NONCONFORMANCE REPORT

NCR # 130613MLa

Production District HOG Sask West Facility Lilydale Comp Stn LSD 08-07-046-24W3
Equipment Description Inlet Scrubber Manufacturer Rambler Fab Husky ID # 66178606
Prov. Registration # SK Licence #7026537 CRN R2661.23 Serial # 2373-2

SUBJECT: Overpressure protection of inlet separator

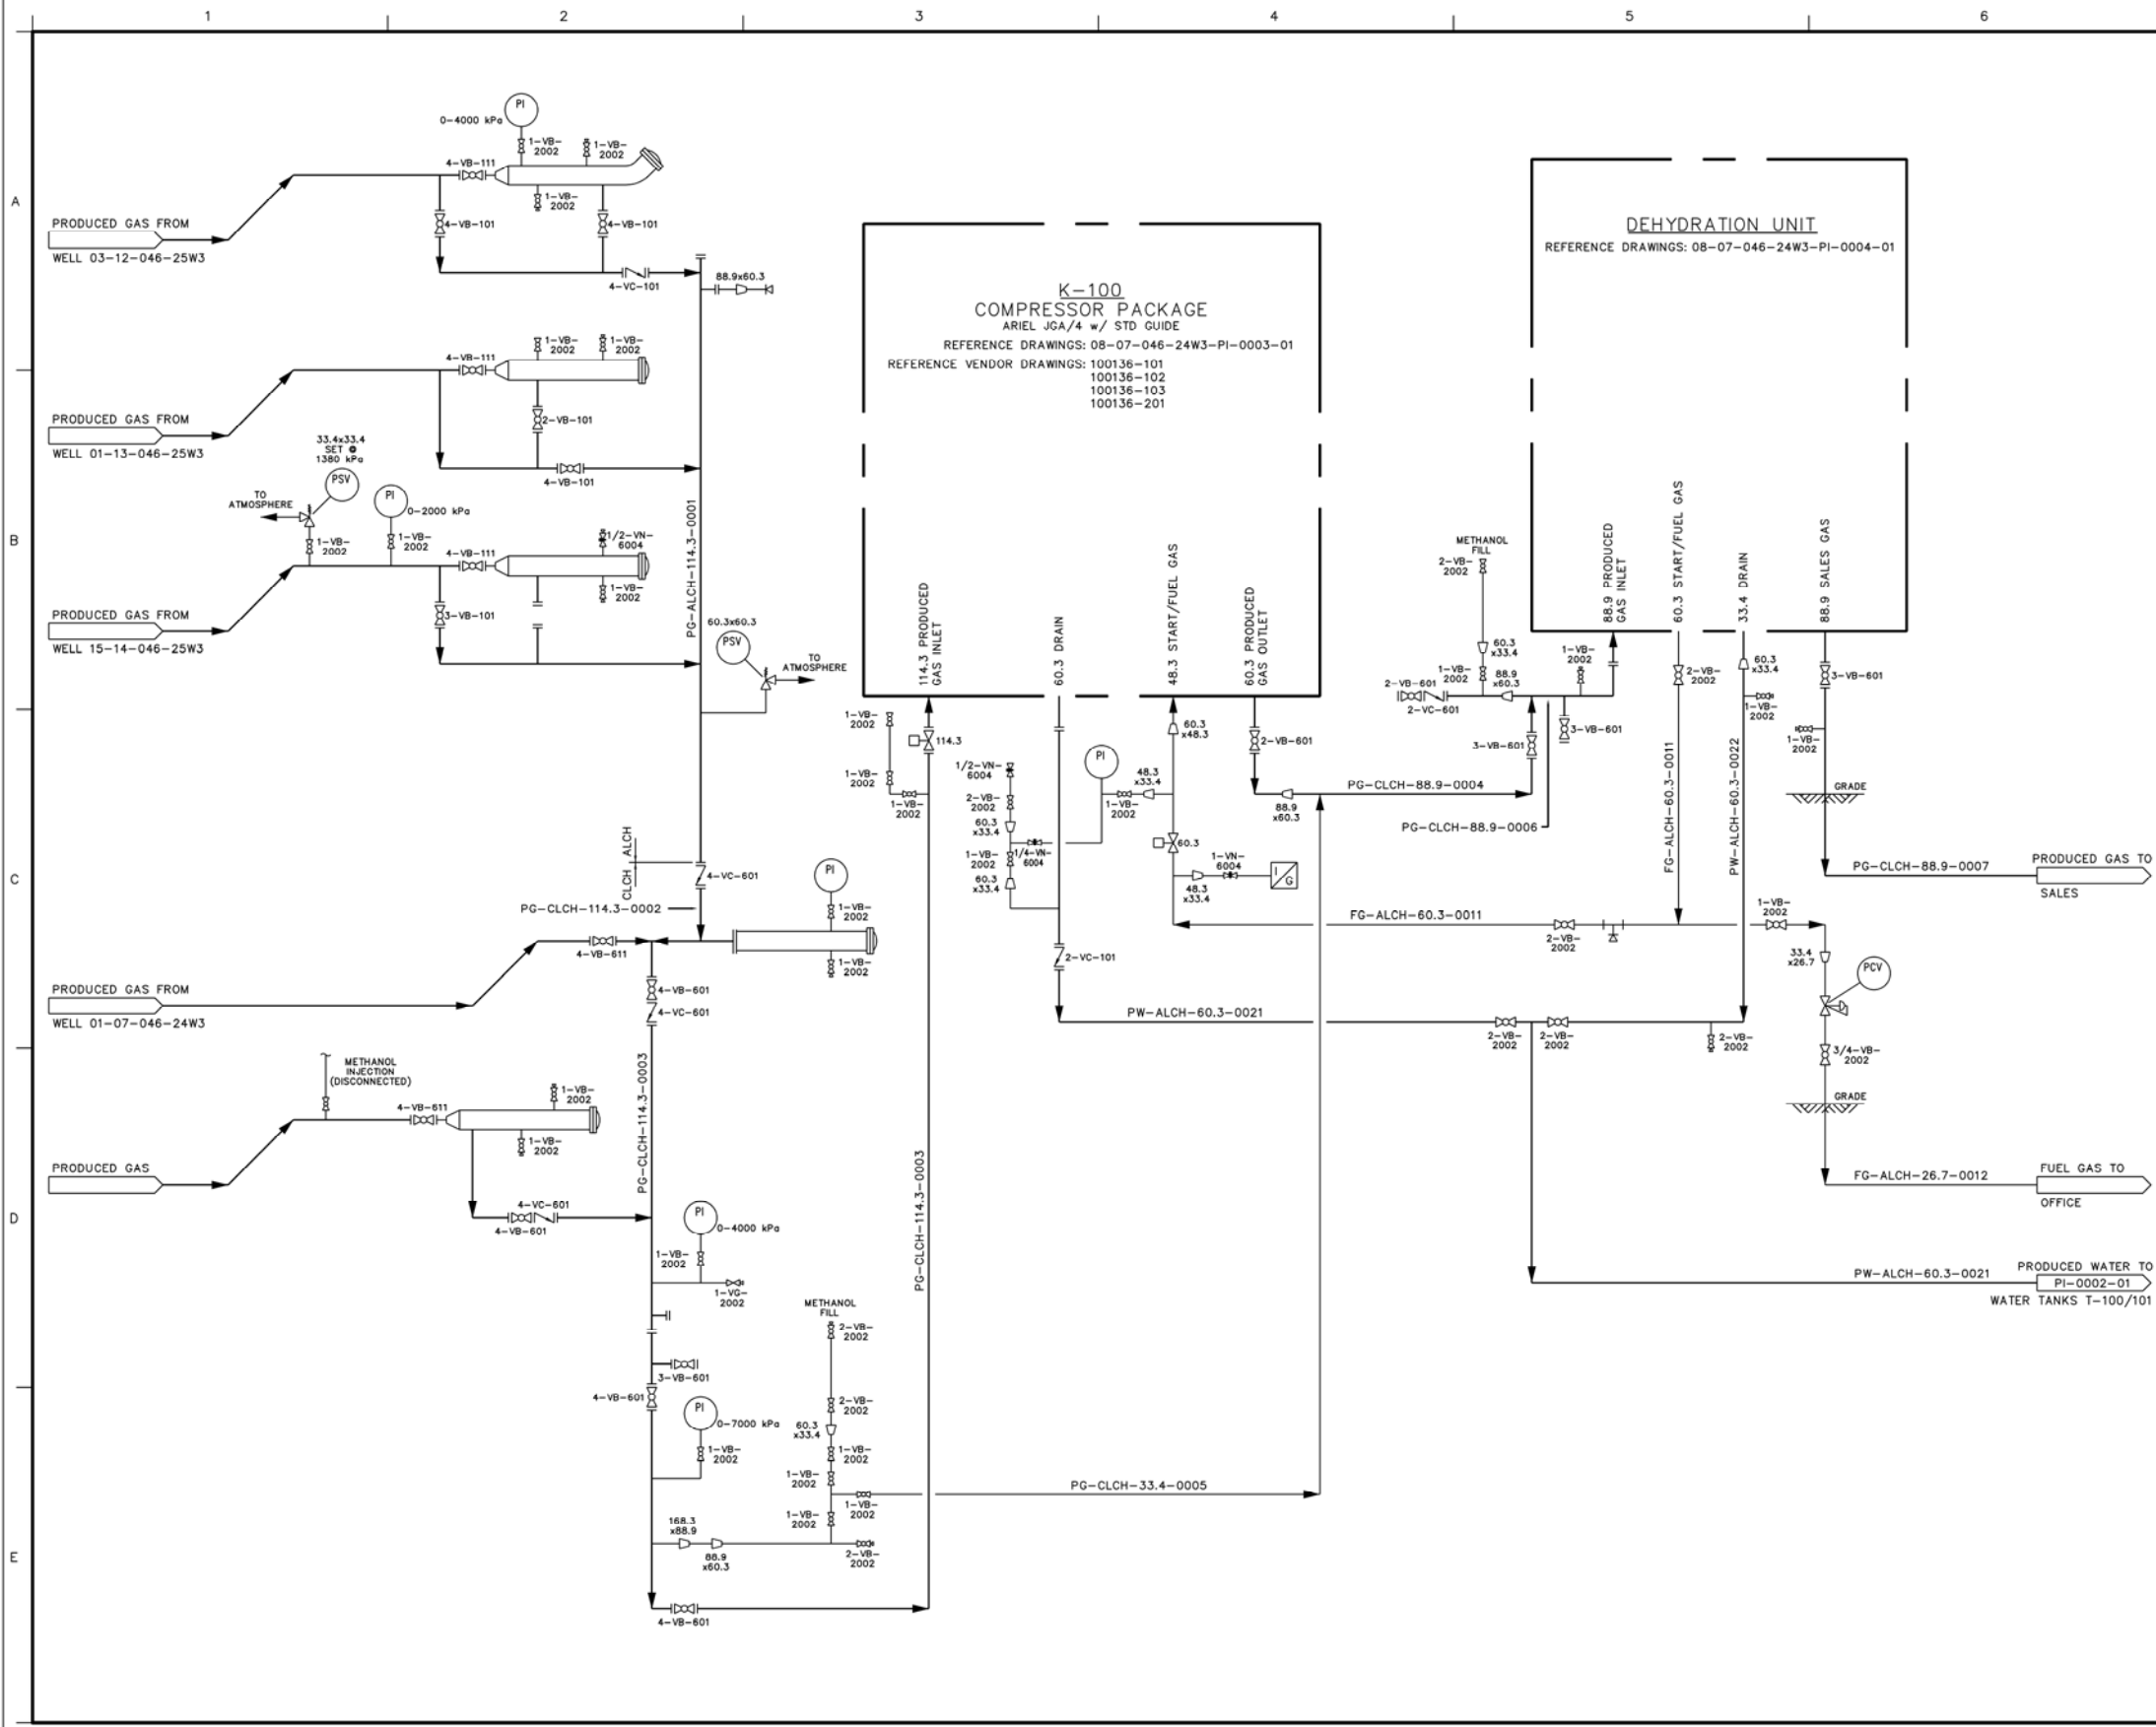
- NCR # 130613MLa mentions that there is no PSV protection on the knock-out vessel (inlet scrubber, V-1 see drawing 08-07-046-24W3-PI-0003-01). This memo is to show that the system is adequately protected as designed and built.
 - The fluid service is sweet, produced gas.
-

- In the case of an overpressure event upstream of the compressor package inlet (see drawings 08-07-046-24W3-PI-0003-01 and 08-07-046-24W3-PI-0001-01), the compressor package is provided with pressure switches at the suction line set at 2275 KPag, they will shut down the compressor if the pressure increases to that value at the inlet line, then the PSV downstream the first stage will relief if necessary at 4137 KPag. The only line feeding this package is the line from the well 15-14-048-25W3, at that part of the inlet header there is a PSV with a set point of 1965 Kpag. The maximum overpressure event from the suction side will be limited to the value of 4965 KPag, which at this moment is from lines not being used, from 01-07-046-24W3 and/or 07-14-046-24W3.
-

- The configuration on the compressor is a typical design common to many compressors in the upstream industry. The suction side vessels are protected by the PSV on the discharge side of the first stage because there are no intervening block valves in the process. The suction and discharge valves in the cylinders are essentially check valves and will always allow flow from the suction side to the discharge side in the event of an upstream overpressure event.

- The pressure ratings for the suction side vessels are all 4826 kPag and PSV 100 is set at 4137 kPag so there is adequate margin to cover for any pressure loss through the cylinder valves (this is very small). In a case of an overpressure event by fire expansion, the system is protected.

- The pressure vessel is protected by a PSV downstream the compressor's 1st stage. This PSV is set to 4137 KPag, and the MAWP for that vessel is 4826 Kpag.
-
